ASHLAND PLANNING DEPARTMENT SITE: 348 N Main
PRE-APPLICATION CONFERENCE APPLICANT: Laura Sainz
COMMENT SHEET REQUEST: Multi Family Development
October 12, 2022 Possible subdivision.

PLANNING STAFF COMMENTS:

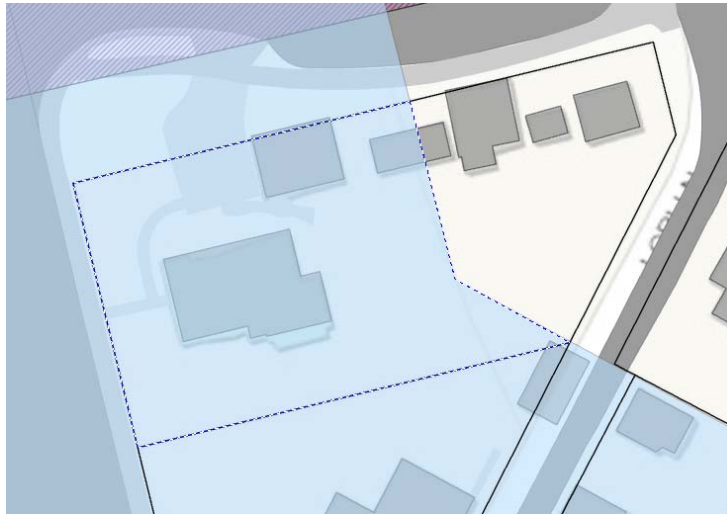
Initial assessment is that the proposal will require a total of six parking spaces. On street credits are discretionary, and can only be up to one half of the parking demand. If the applicant were interested in developing additional off street parking from Lori Ln. staff would be in favor of treating such parking as if it were an alley based on its width and development status.
